Draft Memorandum

To: David Kliegman, Okanogan Highlands Alliance
From: Ann Maest, Stratus Consulting Inc.
Date: 7/2/2010
Subject: Comments on Kinross/Crown Resources June 24, 2010 Letter to the Washington Department of Ecology regarding the Action Plan for Observed Seepage in Gold Bowl Creek

Figure 3. Increasing concentrations of chloride and nitrate in surface water locations SW-9 and SW-7. Vertical dashed line indicates the start of mining operations; vertical dotted lines indicates the beginning of water year 2009.

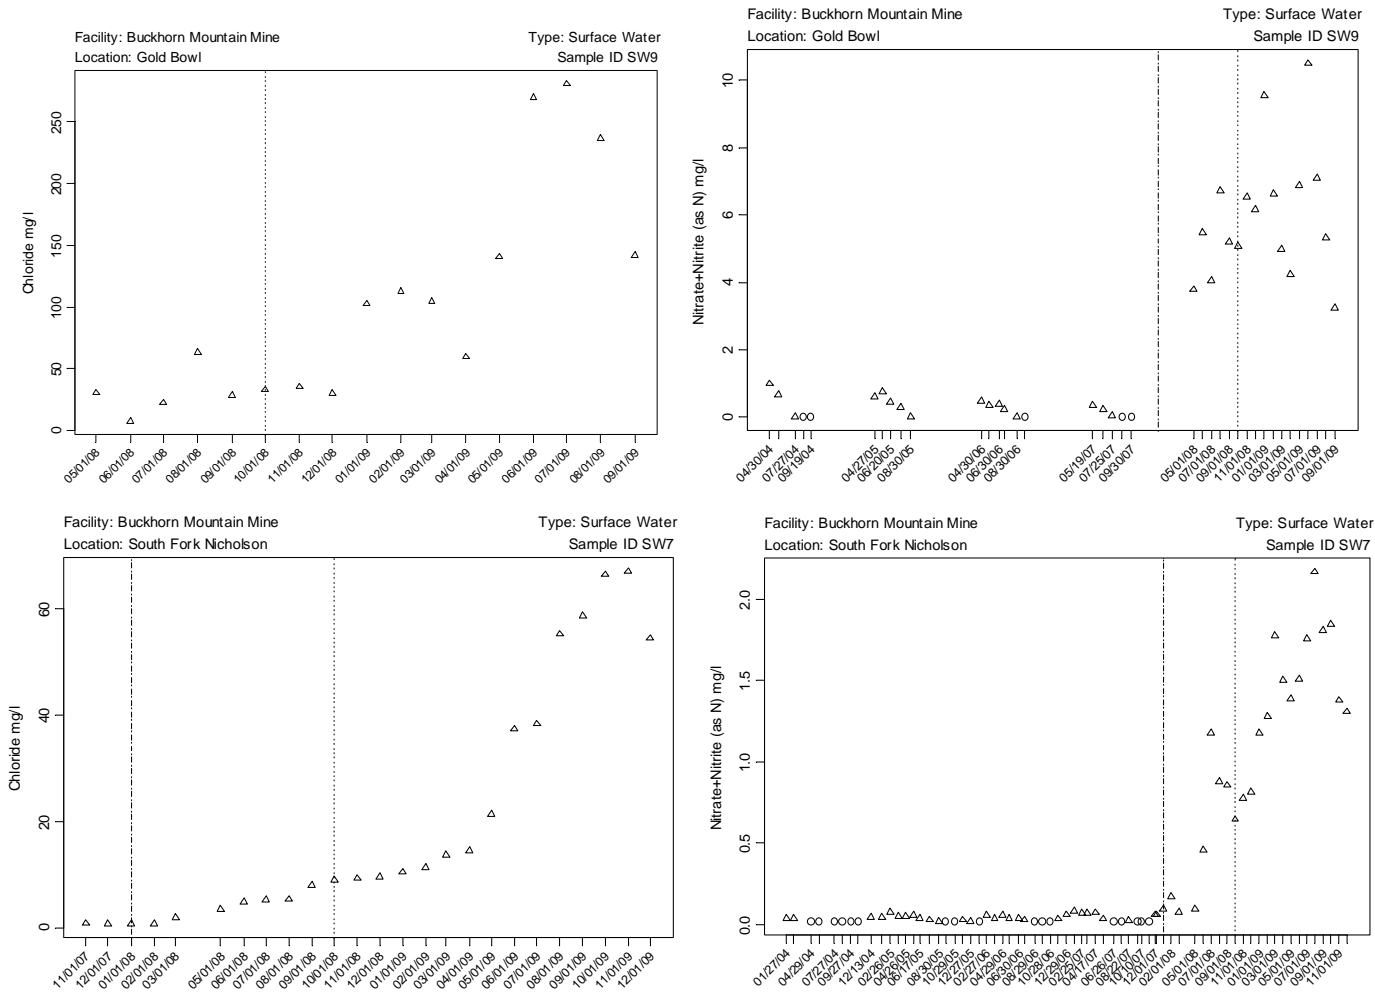
Although no State surface water standards have been exceeded at the SW-7 and SW-9 surface water locations, concentrations of mine-related contaminants have been increasing and pH has been dropping at these locations, mostly since late 2008. Figure 3 shows increasing concentrations of chloride and nitrate at SW-9 and SW-7 through water year 2009. Increasing chloride concentrations are from treated effluent that was either released at outfall 002 or stored in the underground mine. Nitrate concentrations at SW-9 and SW-7 showed an increase as early as May 2008 (samples are not collected in the winter months at SW-9, so the increase might have occurred even earlier). TDS concentrations at SW-9 and SW-7 did not increase notably until mid-2009. Sulfate concentrations peaked in mid-2008 at SW-9 and SW-7 (~160 and 70 mg/L, respectively) and had been decreasing, but have recently increased to 257 mg/L at SW-9 in May 2010. Field pH values may be decreasing at both SW-9 and SW-7 (since about late 2008).

Figure 4. Increasing concentrations of chloride, depth to water, sulfate, and nitrate in monitoring well MW-14.

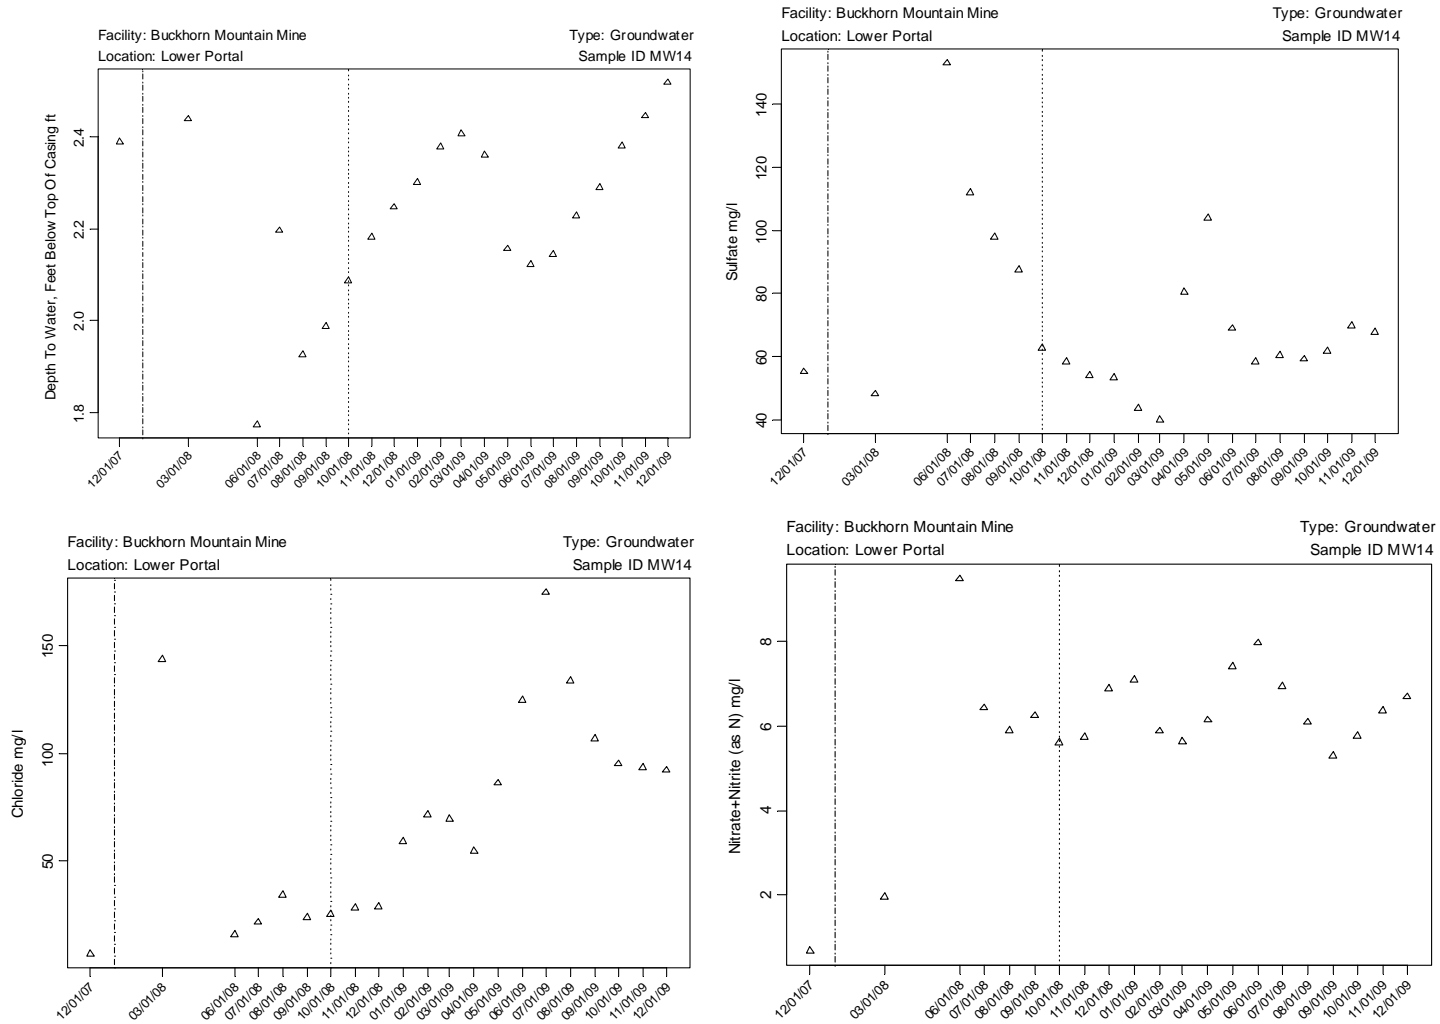
Concentrations in monitoring well MW-14 exceeded State groundwater quality standards for TDS, sulfate, and nitrate (State of Washington, 2010) in 2010, yet Kinross makes no mention of these exceedences in their letter. Concentrations of all three constituents have increased in 2010 over values in 2009, and values did not exceed standards before 2010. Figure 4 shows depth to water and increasing concentrations of chloride, sulfate, and nitrate in MW-14 through water year 2009. Concentrations in May 2010 were 696 mg/L TDS, 288 mg/L sulfate, and 10.5 mg/L nitrate+nitrate (mg/L as N). State standards for these constituents are 500 mg/L, 250 mg/L, and 10 mg/L, respectively.

Figure 5. Increasing concentrations of chloride and nitrate, decreasing pH values, and decreasing flows in seeps at the mine through water year 2009.

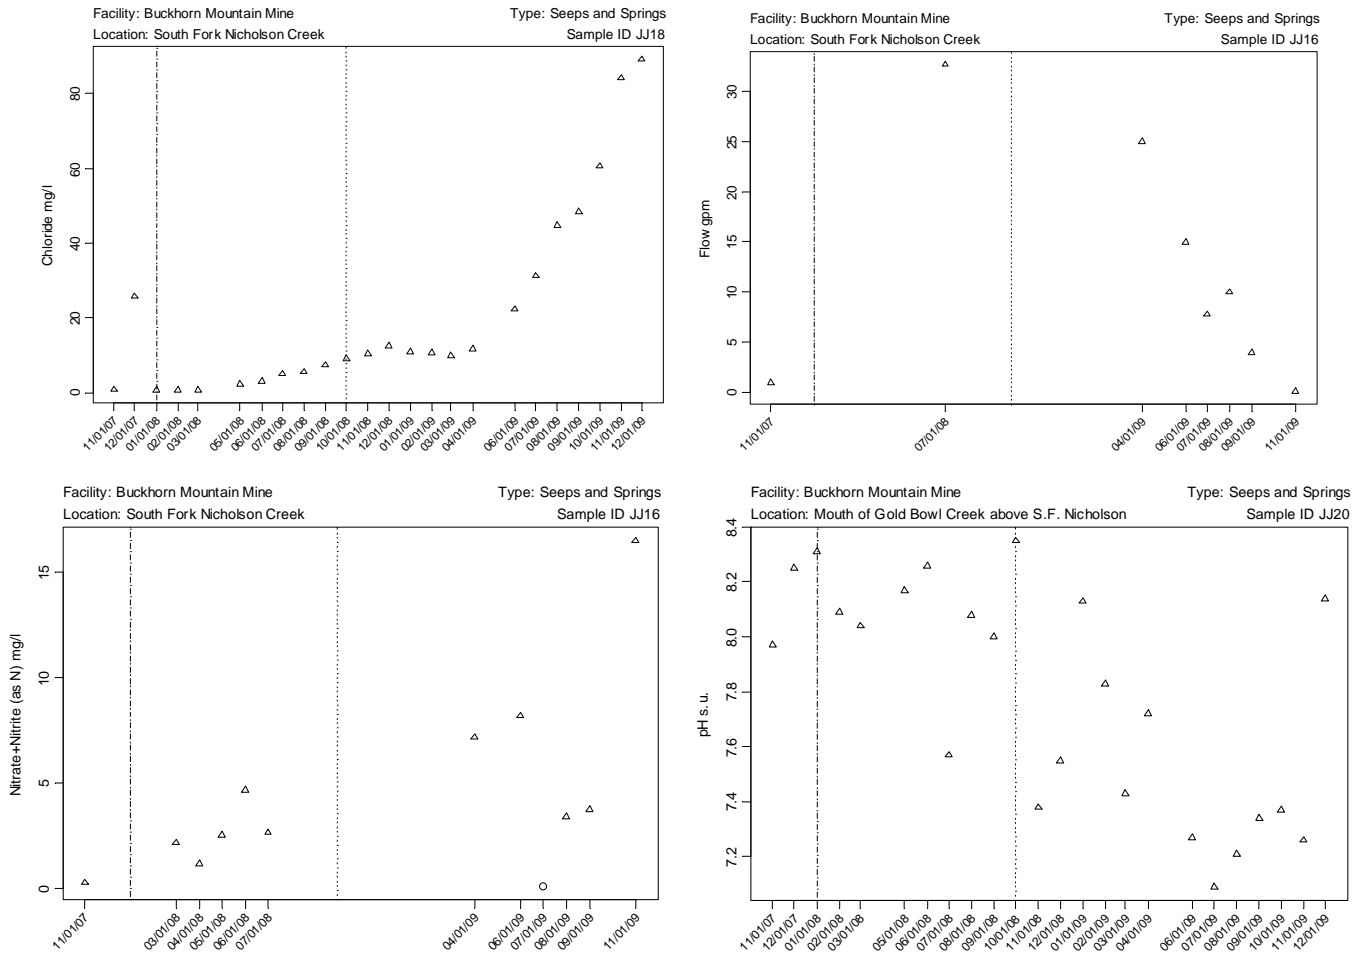
The Kinross June 2010 letter to DOE notes that concentrations of mine-related constituents have increased in spring JJ-21 and that flows have decreased. However, the letter does not note that concentrations have been increasing at other seeps in the mine area as well since mining began (dewatering began in January 2008). For example, concentrations of chloride, nitrate, and TDS have been increasing relative to pre-mining values at seeps JJ-21, JJ-16, JJ-18, SN-22, JJ-20, and RAS-1. Flows have decreased at JJ-20 and JJ-16 but increased at JJ-21; pH values have decreased at JJ-15, JJ-20, JJ-18, and SN-22. Figure 5 shows increasing concentrations of chloride, decreasing flows, increasing nitrate concentrations, and decreasing pH values in seeps at the mine through water year 2009. Nitrate concentrations in seep JJ-16 were higher than State groundwater or surface water standards (10 mg/L nitrate+nitrite as N) in water year 2009.
